## COMMUNITY FINANCIAL CREDIT UNION JSP24-08

Public Hearing at the request of Level 5 Construction LLC for Preliminary Site Plan, Woodland Permit, and Stormwater Management Plan approval to build a Community Financial Credit Union. The subject parcel is zoned TC, Town Center District and is located at the northeast corner of Crescent Boulevard and Grand River Avenue. The applicant is proposing a 3000 square foot building on 1.57 acres of land.

# PLAN REVIEW CENTER REPORT

Revised Preliminary Site Plan

1 SITE - PHOTOMETRICS PLAN  
1/4" = 1'-0"

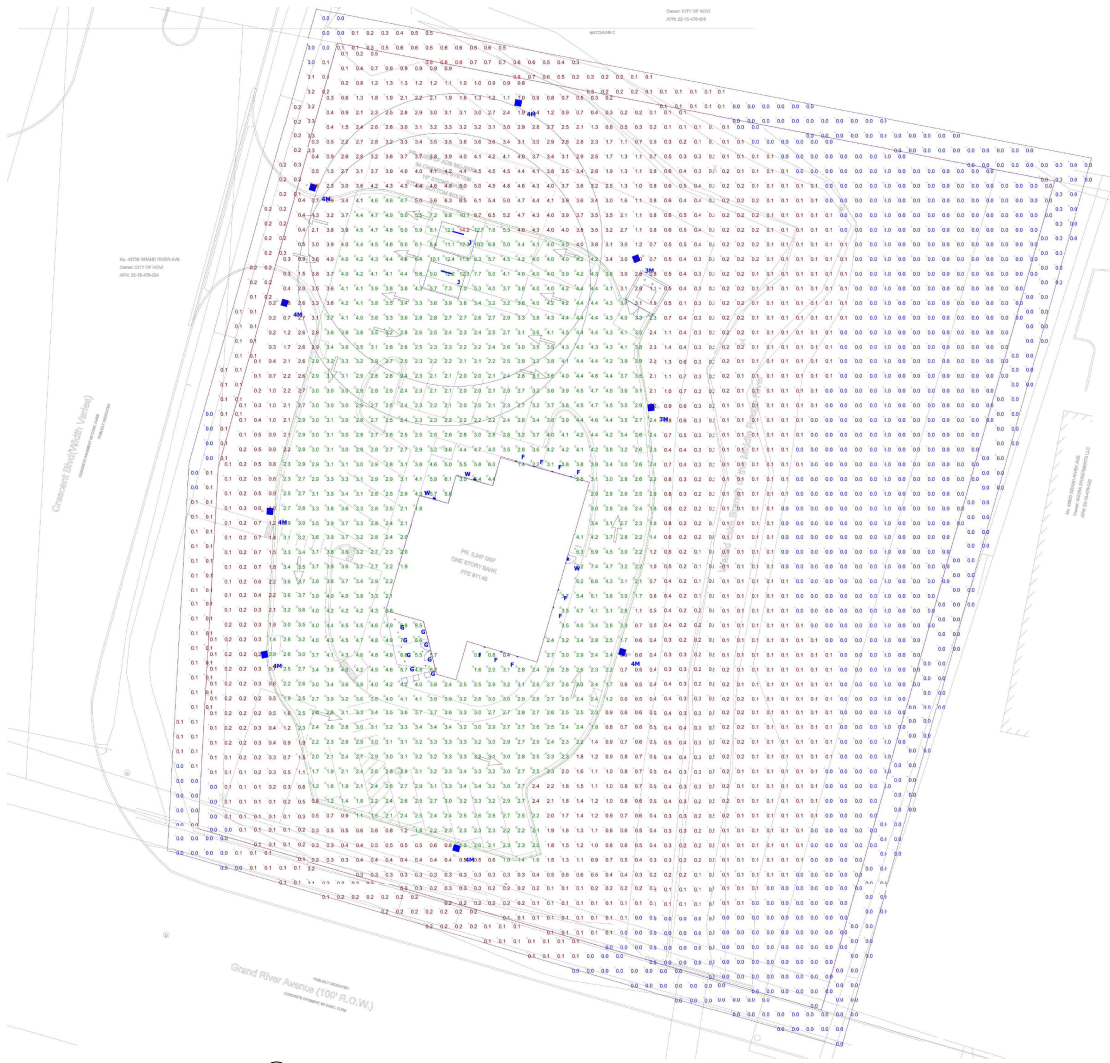
20. Color Spectrum Management (Sec. 5.7.3.F): Non-Res and Multifamily: For all permanent lighting installations - minimum Color Rendering Index of 70 and Correlated Color Temperature of no greater than 3000 Kelvin. **Please clarify which lamps are to be installed on the site plan. Please see planning chart for additional information.**

21. Average Light Level (Sec. 5.7.3.L): Average light level of the surface being lit to the lowest light of the surface being lit shall not exceed 4:1. **This calculation was not completed correctly. The Average:Minimum calculation should be inclusive of the entire site, not be made into two separate calculations for the parking lot area and “site zones”—please revise this.**

18. A detail of the benches will be included in the final site plan submittal
19. The landscape plan sheet L2 proposes plantings to screen the transformer.
20. The proposed lamps will be clarified on the final site plan submittal.
21. The average lighting levels calculations will be updated as requested on the final site plan submittal.

NORTHWEST ELEVATION

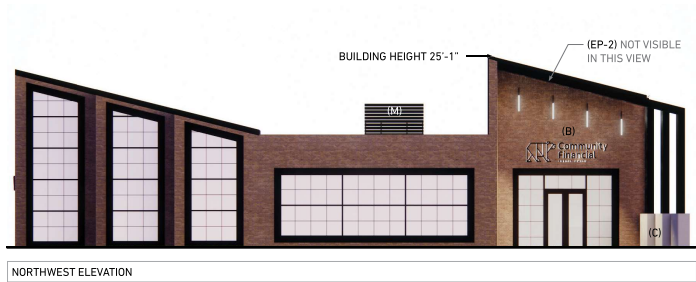
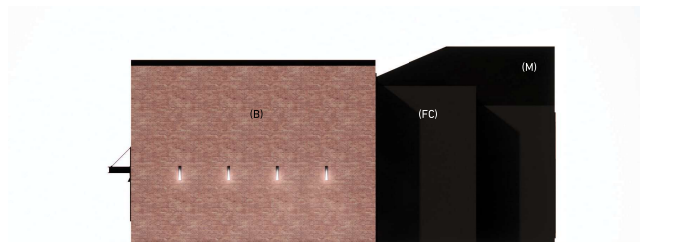
16. Façade materials (Sec. 3.27.1.G): All sides of the building and accessory buildings must have the same materials. Façade materials may deviate from brick or stone with Planning Commission approval. 57%-75% brick facades proposed. **A section 9 façade waiver will be required from the Planning Commission for the overage of cast-in-place concrete near the main building entrance— Applicant has acknowledged this.**

**Figure 1. City of Novi Regulated Woodlands Map**  
 Approximate parcel boundary is shown in Red.  
 (Approximate) Regulated Woodland areas are shown in Green

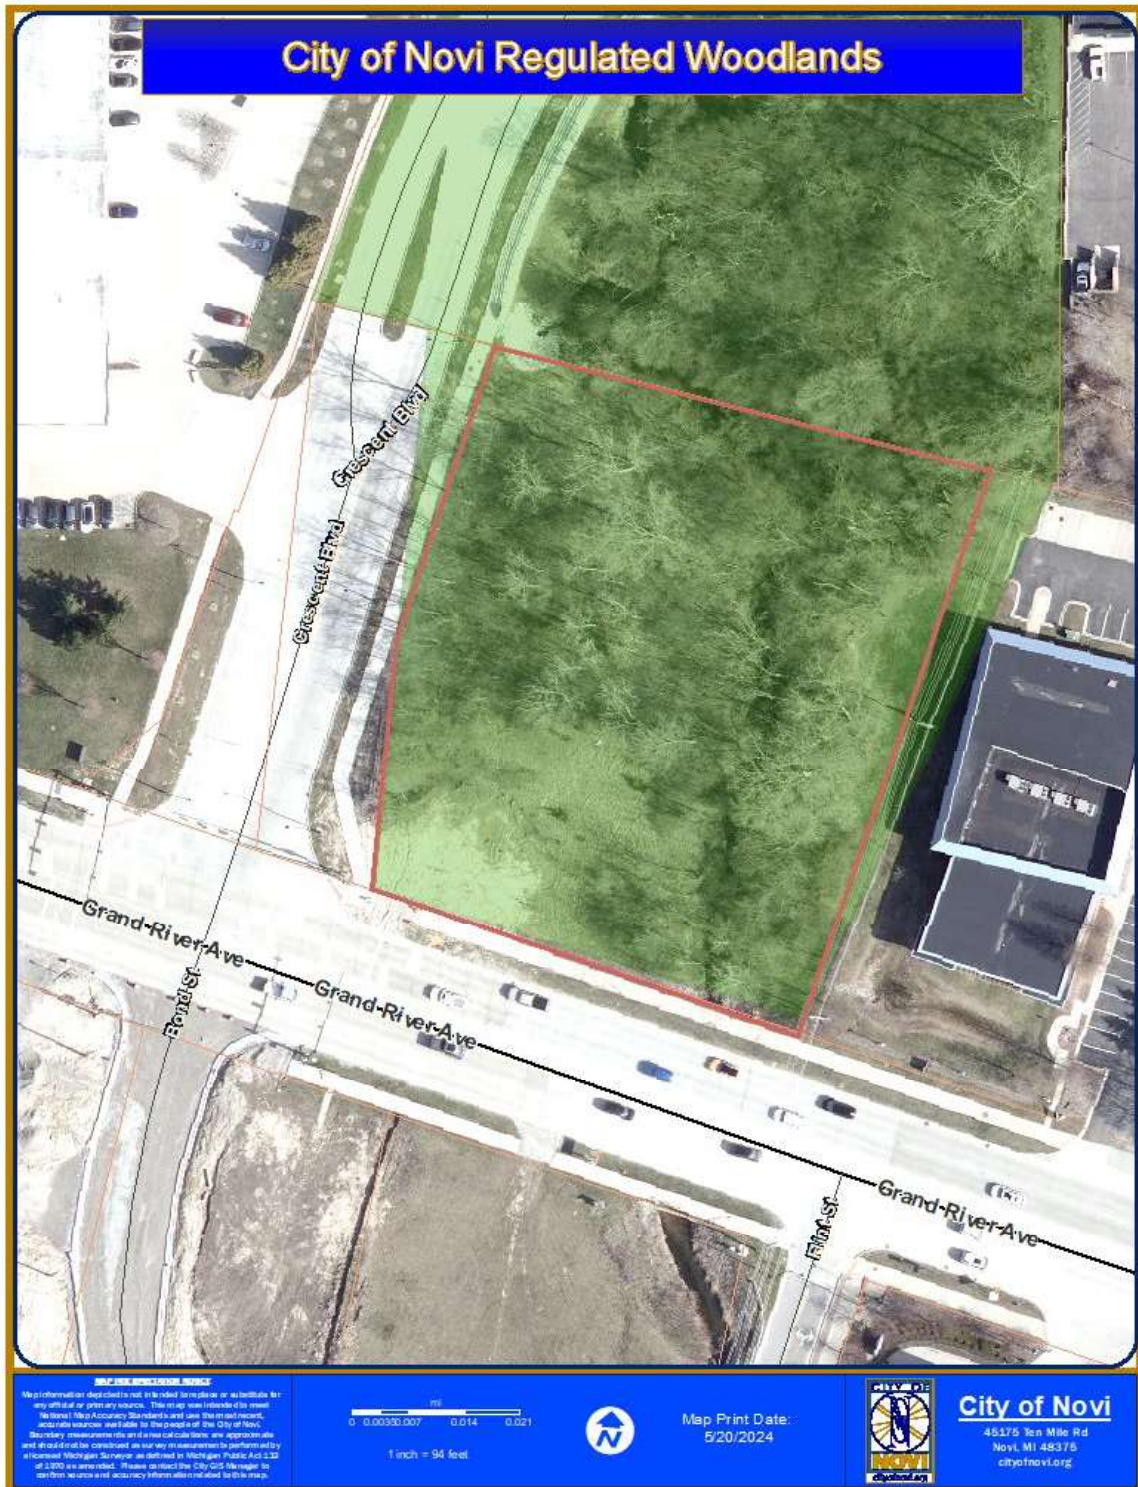
1. City-regulated woodlands, as identified on the City of Novi Woodlands interactive map website, are present onsite. Note that both the woodlands and property limits depicted on the City map are considered approximations (**Figure 1**).
2. Merjent conducted a site visit on May 15, 2024 to review the site conditions relative to the PSP submittal. Site photographs are included in **Attachment A**. The on-site conditions reflect the conditions listed in the PSP.
3. When a proposed site plan is located within a regulated woodland, any tree proposed for removal with a diameter at breast height (DBH) greater than or equal to eight inches will require tree replacement

**Figure 2. City of Novi Regulated Wetlands Map**  
 Approximate parcel boundary is shown in red.  
 (Approximate) Regulated Wetland areas are shown in turquoise.

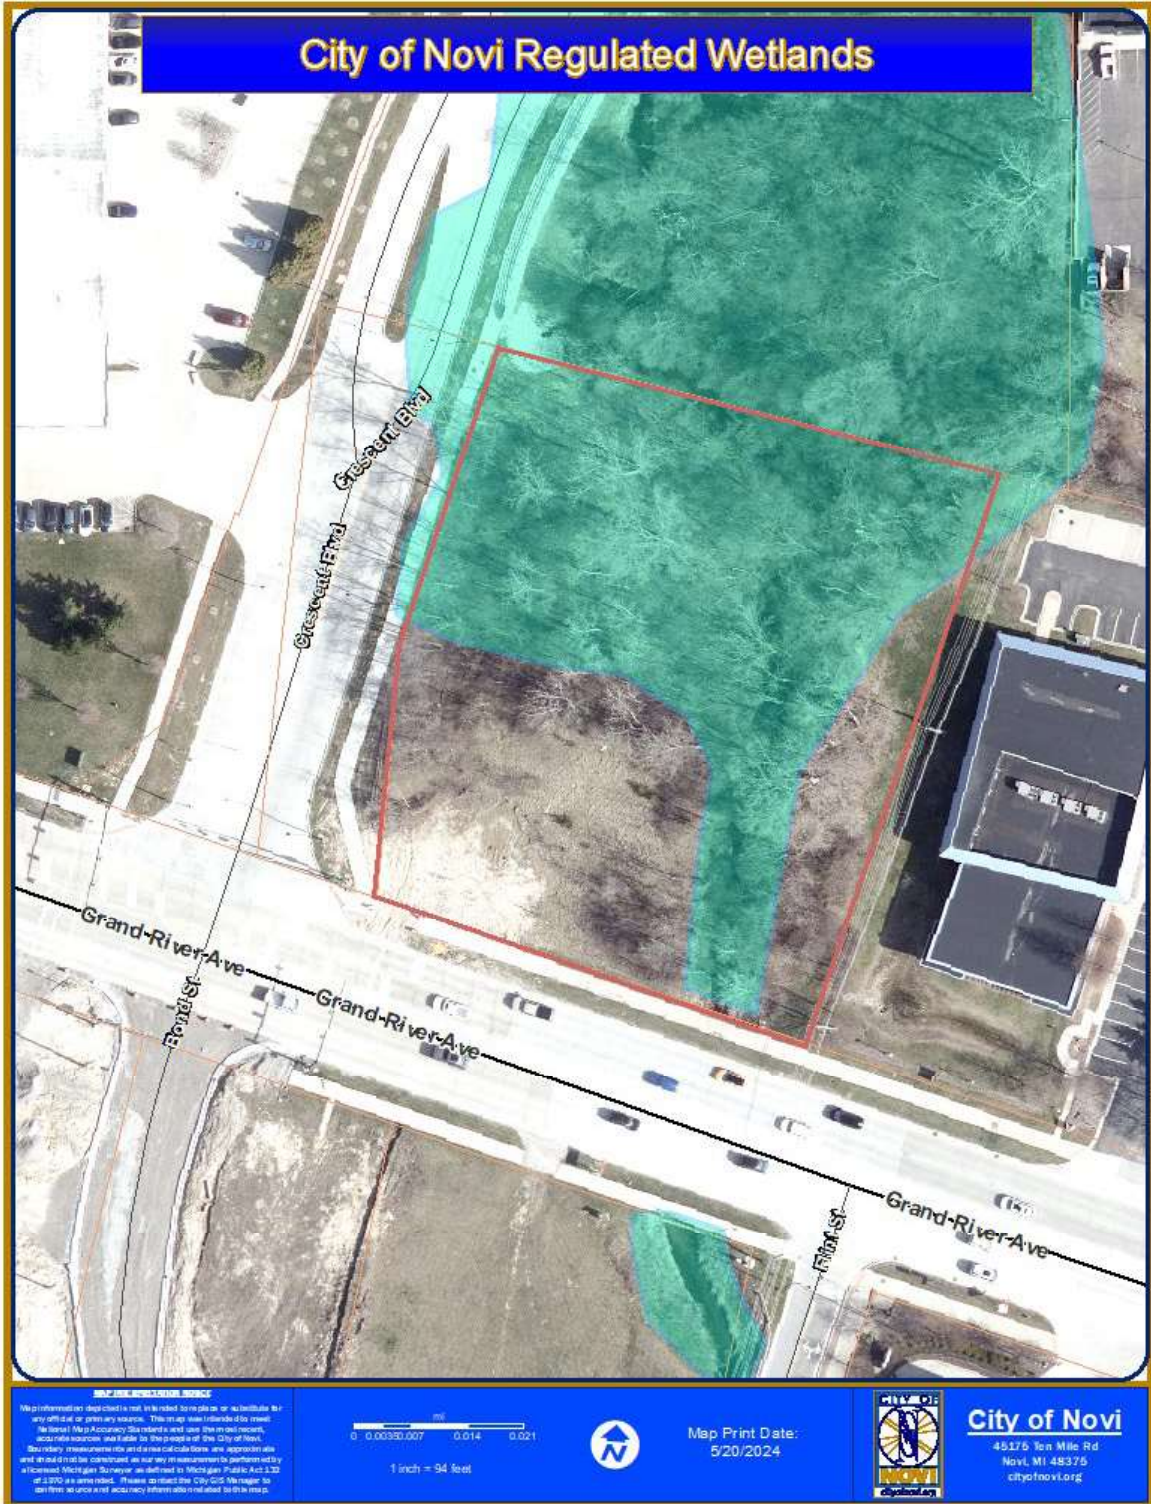
- City-regulated wetlands, as identified on the City of Novi interactive map website. Note that both wetland and property limits depicted on the City’s map are considered approximations (**Figure 2**).
- Wetlands that are regulated by the Michigan Department of Environment, Great Lakes, and Energy (EGLE).
- Wetlands as identified on National Wetland Inventory (NWI) and Michigan Resource Inventory System (MIRIS) maps, as identified on the EGLE Wetlands Viewer interactive map website (**Attachment B**). NWI and MIRIS wetlands are identified by the associated governmental bodies’ interpretation of topographic data and aerial photographs.
- Hydric (wetland) soil as mapped by the U.S. Department of Agriculture, Natural Resources Conservation Service, as identified on the EGLE Wetlands Viewer interactive map website (**Attachment B**).
